Reliability Analysis Update

Transmission Expansion Advisory Committee

April 6, 2021

Changes to Existing Projects

115kV Line #81 and 230kV Lines #239 and #2056 Partial Rebuild

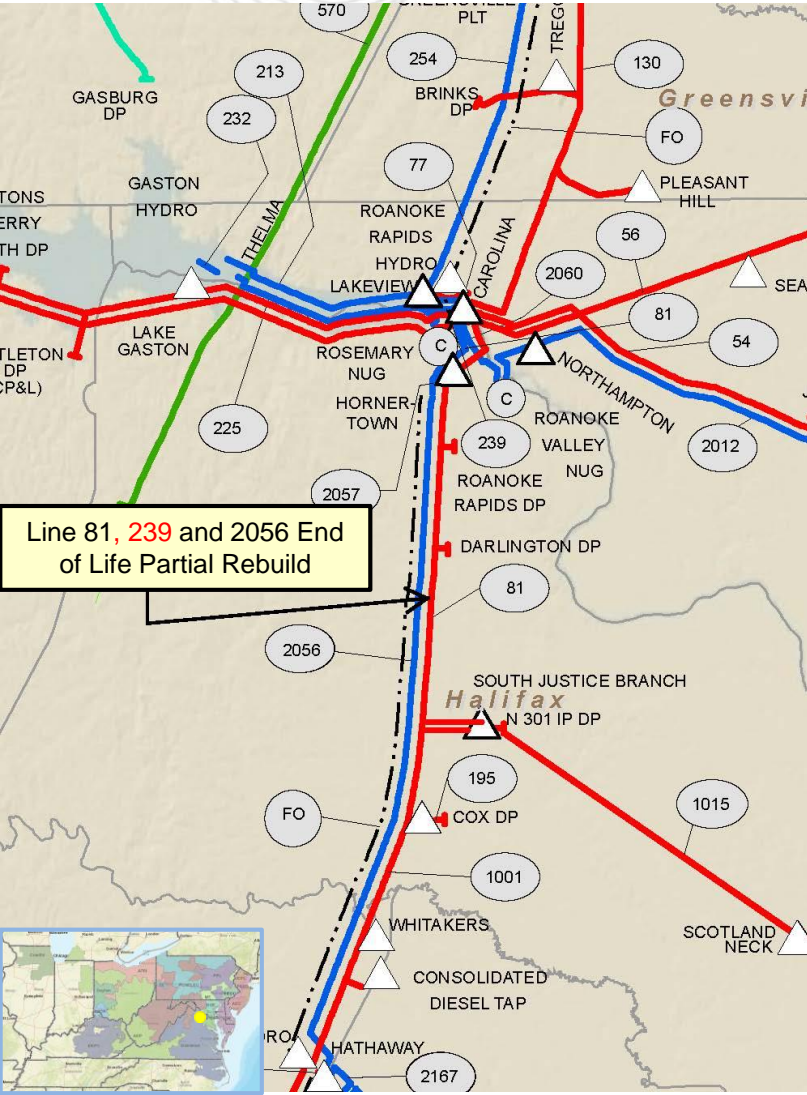
Problem Statement: Dominion “End of Life Criteria”

- 115kV Line #81 extends 21.6 miles from Carolina to South Justice Branch and serves 3 delivery points: Roanoke Rapids DP, Darlington DP, and Hornertown. The 18.6 mile section between Carolina and the tap to South Justice Branch is mostly wood H-frames constructed in 1959.

- There are two sections, 1.7 miles total, within the 18.6 mile section that have double circuit structures that are V series Corten. 115kV Line #81 and 230kV Line #2056 are on these double circuit structures. **Additionally, 115kV Line #81 and 230kV Line #239 are on double circuit steel structures for 1.3 miles within the 18.6 mile section. These structures were installed in 1967.** The conductor on this line is ACSR and the static wire is 3/8 inch steel.

- Industry guidelines indicate equipment life for wood structures is 35-55 years, conductor and connectors are 40-60 years, and porcelain insulators are 50 years.

115kV Line #81 and 230kV Lines #239 and #2056 Partial Rebuild

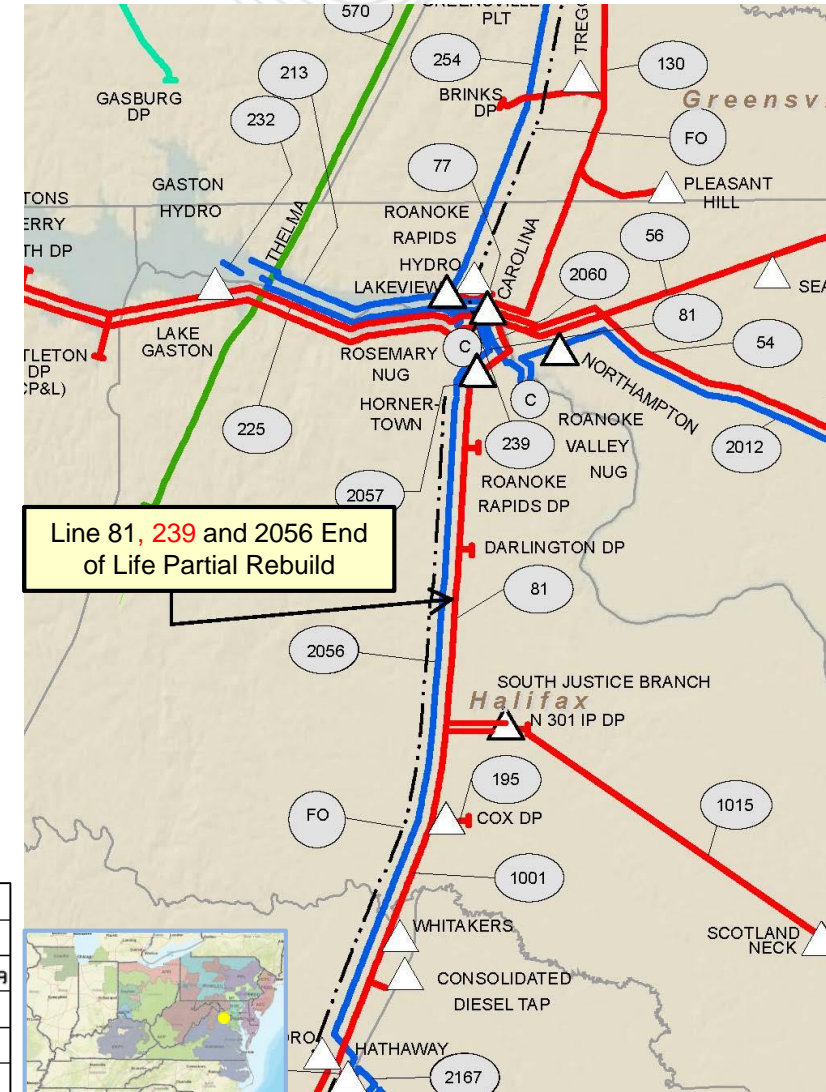
Rebuild the 18.6 mile section of 115kV Line #81 which includes 1.7 miles of double circuit Line #81 with 230kV Line #2056 and 1.3 miles of double circuit Line #81 with 230kV Line #239. This segment of Line #81 will be rebuilt to current standards with a minimum rating of 261 MVA. This segment of Line #239 will be rebuilt to current standards with a minimum rating of 1046 MVA. Line #2056 rating will not change. (b3114)

Chickahominy 230kV Breaker “SC122”, “205022”, 209122”, 210222-2”, “28722”, “H222”, “21922”, “287T2129” Replacements

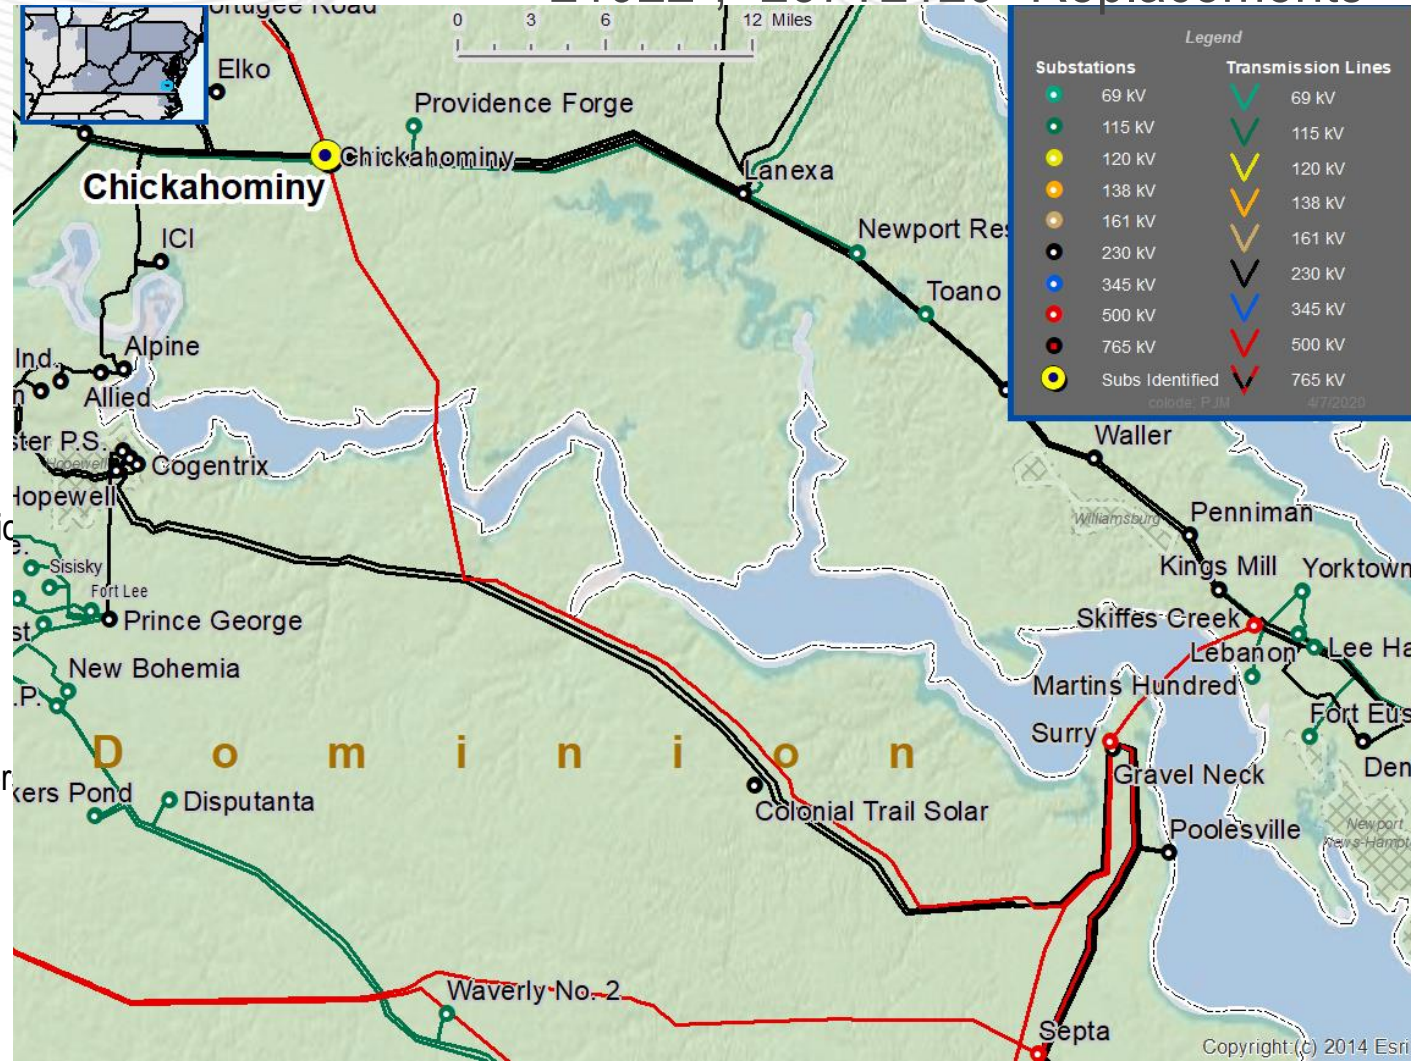
Eight (8) Chickahominy 230kV breakers are over duty: “SC122”, “205022”, 209122”, 210222-2”, “28722”, “H222”, “21922”, “287T2129”

Solution Cancellation Driver: AB2-068 Generator Withdrawn

Recommended Solution Cancellation:

b3213.1: Replace the eight (8) Chickahominy 230kV breakers with 63kA breaker “SC122”, “205022”, 209122”, 210222-2”, “28722”, “H222”, “21922”, “287T2129”

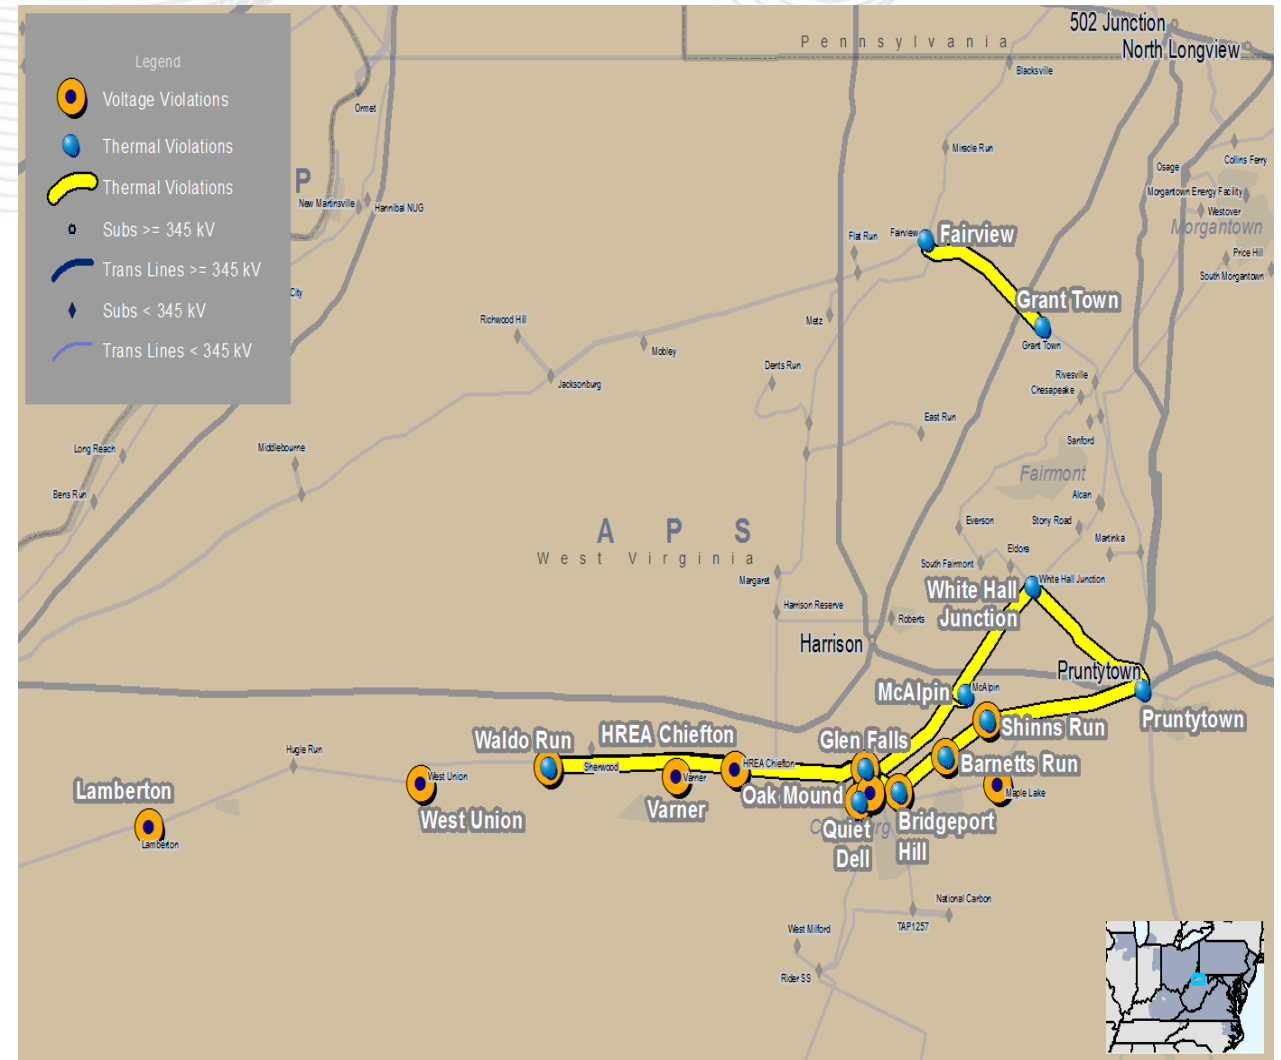
Increased customer load expectations connected to the Waldo Run 138 kV substation are causing several Gen Deliv, N-1 Thermal, and N-1 low voltage violations in the vicinity of Waldo Run, Oak Mound, Pruntytown and Fairview.

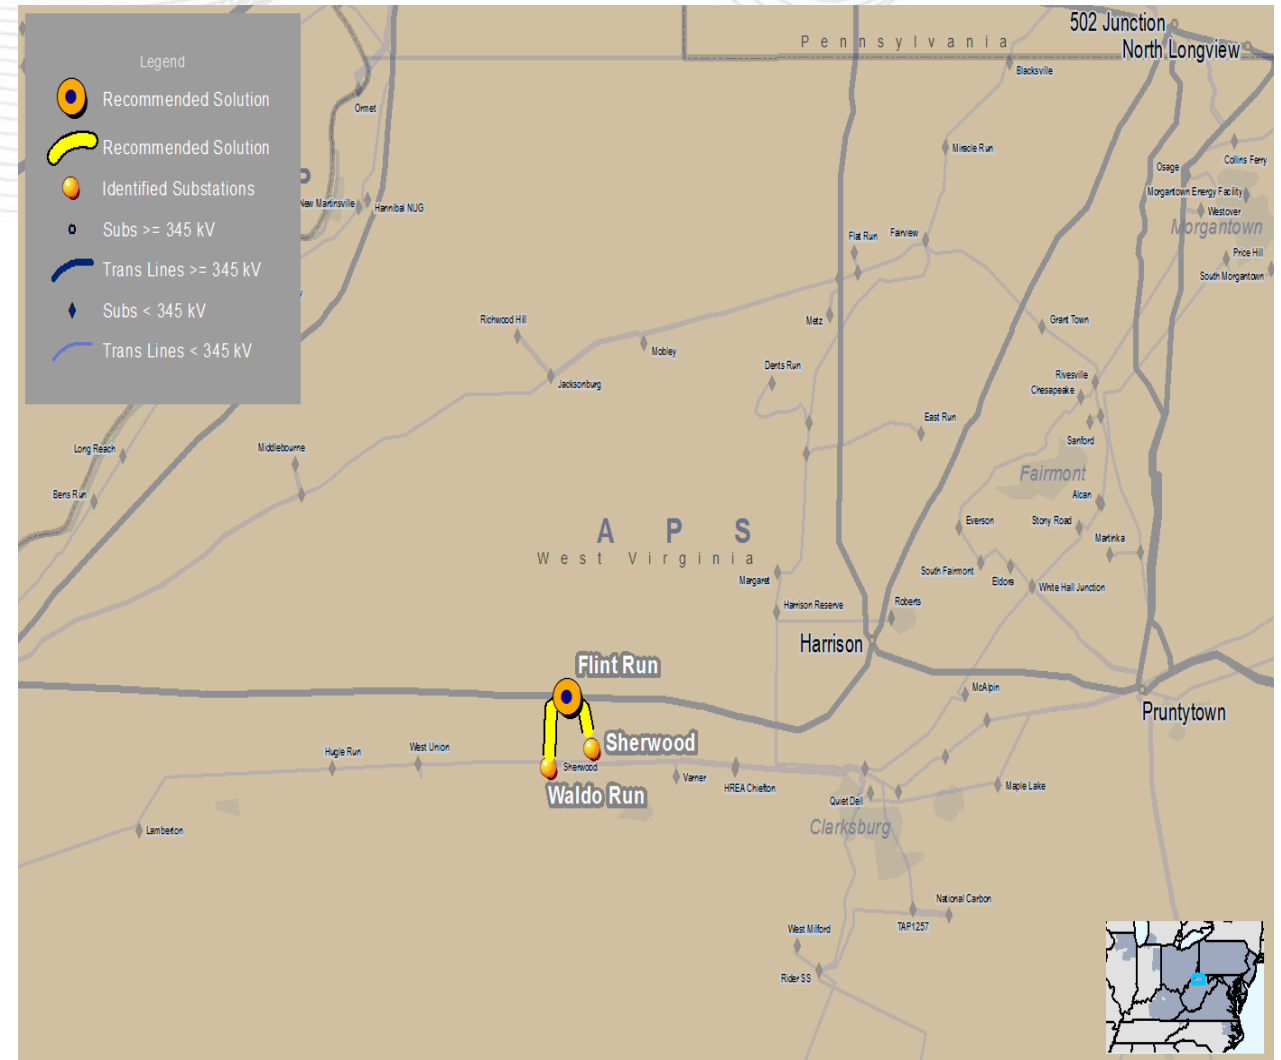
Construct a new 500/138 kV substation as a four-breaker ring bus with expansion plans for double-breaker-double-bus on the 500 kV bus and breaker-and-a-half on the 138 kV bus to provide EHV source to the Marcellus shale load growth area. Projected load growth of additional 160 MVA to current plan of 280 MVA, for a total load of 440 MVA served from Waldo Run substation. Construct additional three-breaker string at Waldo Run 138 kV bus. Relocate the Sherwood #2 138 kV line terminal to the new string. Construct two single circuit Flint Run - Waldo Run 138 kV lines using 795 ACSR (approximately **3.7 miles**). After terminal relocation on new 3-breaker string at Waldo Run, terminate new Flint Run 138 kV lines onto the two open terminals.(b2996.1) **\$125.3M**

Loop the Belmont-Harrison 500 kV line into and out of the new Flint Run 500 kV substation (less than 1 mile). Replace primary relaying and carrier sets on Belmont and Harrison 500 kV Remote End Substations.(b2996.2) **\$16.6M**

Upgrade two (2) existing 138 kV breakers (Rider 50 and #1/4 transformer breaker) at Glen Falls with 63 kA, 3000 A units. (B2996.3) **\$1.5M**

Terrain of 138 kV double circuit

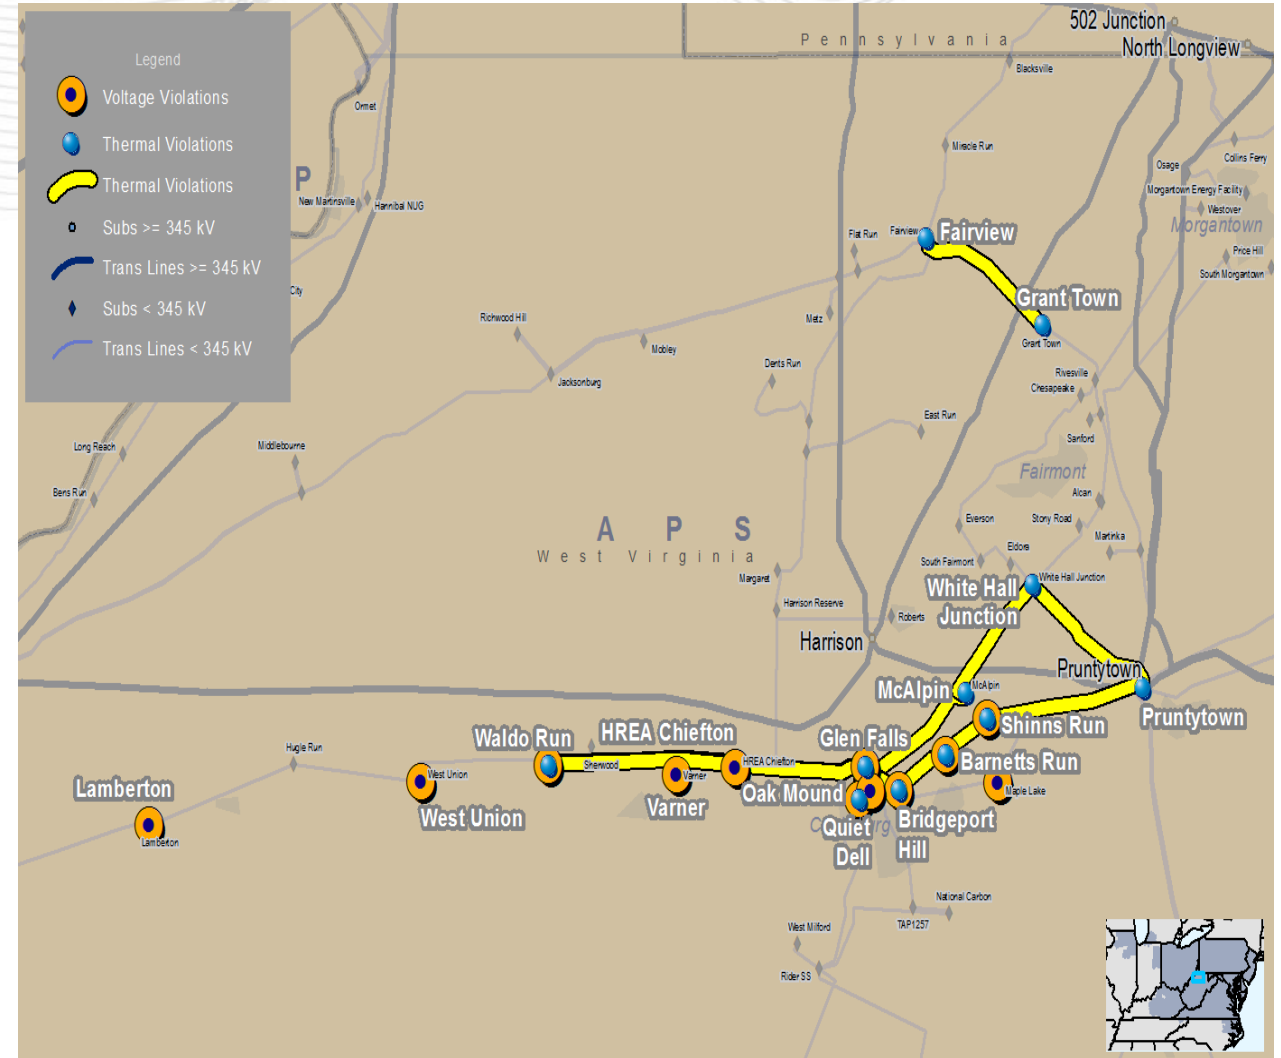
Increased cost of ~\$102M primarily due to:

- 138 kV line work increased **\$43M**
 - Design changed to steel poles
 - Line length increased 0.7 mile
 - Access roads
 - Vegetation control
- Substation location change increased **\$41M**
 - Additional civil and environmental engineering/construction
 - Real estate costs
- Other cost increases **~\$10M**
 - Retaining wall at Waldo Run Substation
 - Additional Engineering, Project Management, etc.
